February 2018 Environmental Update for SLEMA Board

Zhong Liu
February 28, 2018

7.1 North Pile Management Plan

Starter Cell, East Cell, Ditches and Sumps

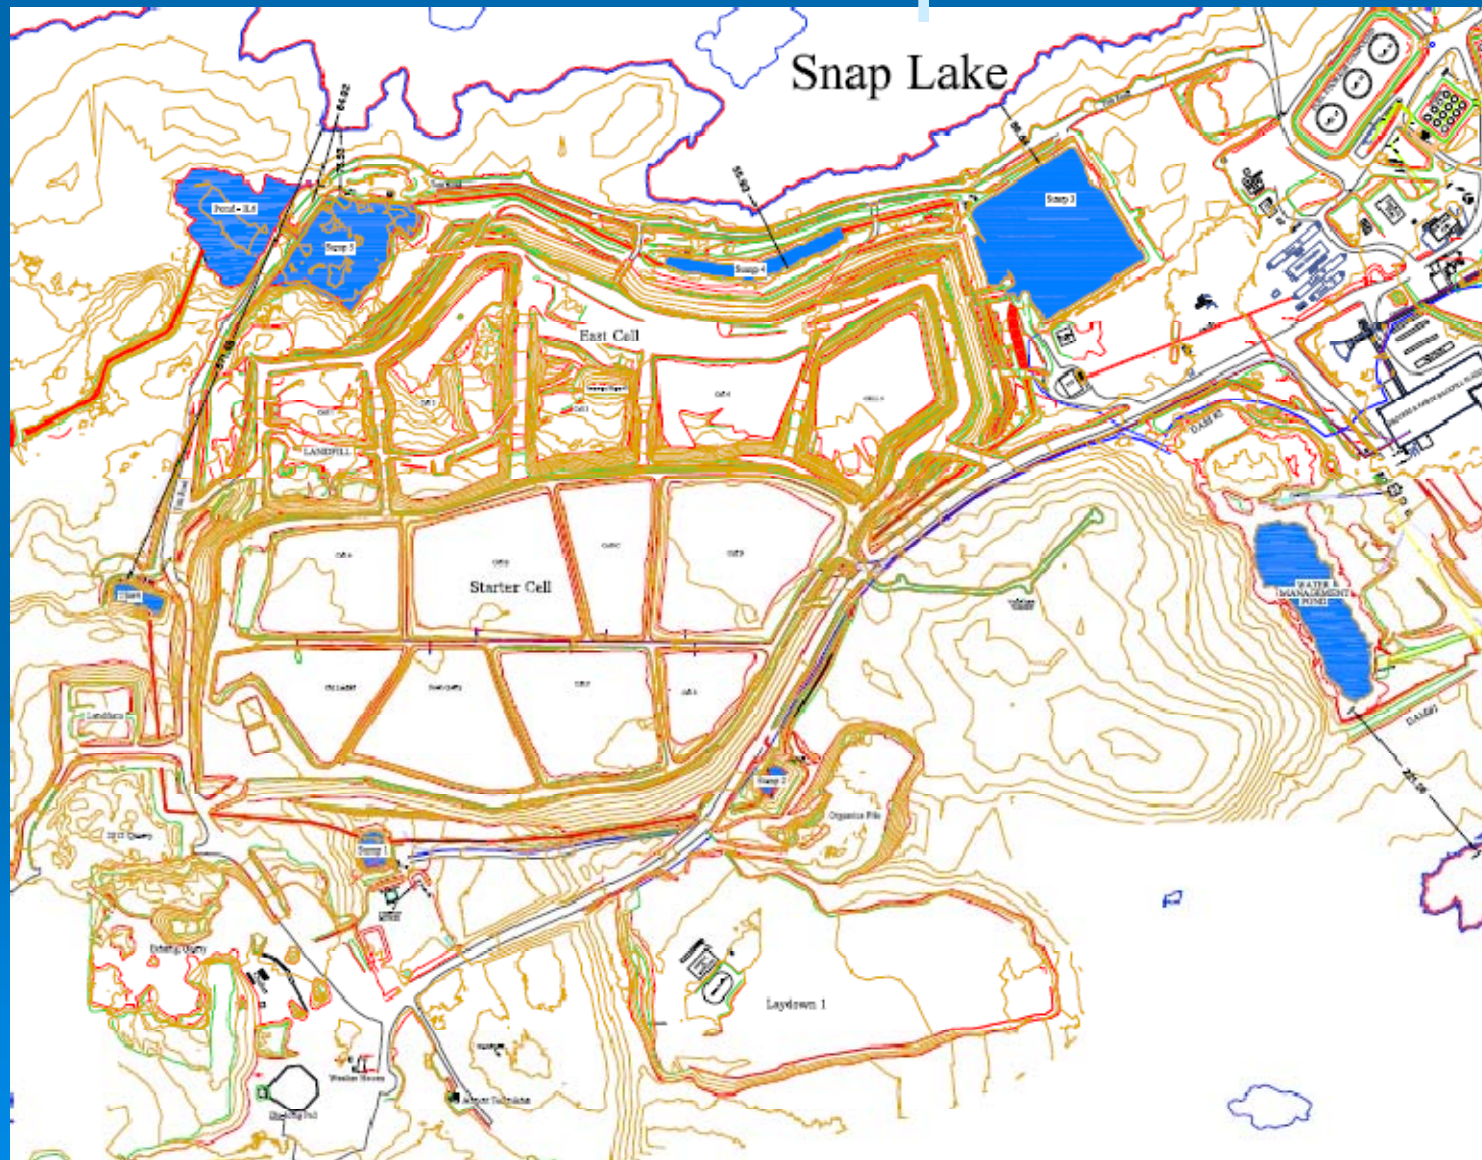
- The Plan appears not to be proofread
 - There are lots of typo errors and editing issues
 - Tables and figures are poorly organized in Revision History, Table of Contents, and in various sections
 - Resubmission is requested

- It is stated in page 1 that the information outlined in this Plan is based on Snap Lake's Extended Care and Maintenance phase and future plans for reclamation and closure of the North Pile. However, the Plan does not provide specific description for "zero occupancy" remote monitoring
 - During the site visit on February 6, 2018, site security surveillance system was demonstrated. However, it might not help the environmental monitoring, especially water monitoring
 - More and consistent information about "zero occupancy" remote monitoring is requested

- In page 23, it is stated that all brine that is collected as a byproduct of the water treatment process will be collected and pumped through to the underground workings
 - Justification of doing so is requested

- Routine daily and weekly inspections are mentioned in page 26 the North Pile monitoring
 - This should be conducted when staff are on site
 - How will the inspections be conducted under the scenario of “zero occupancy” remote monitoring?
 - More information is requested

- It is stated in page 27 that the objective of the third party inspections is to carry out a detailed review of the conditions of the facilities and facility operation during the spring freshet and prior to freeze up
 - There appears to be two third party inspections, i.e. one during the spring freshet and another one prior to freeze-up. However, only one geotechnical inspection was reviewed last year. Clarification is requested
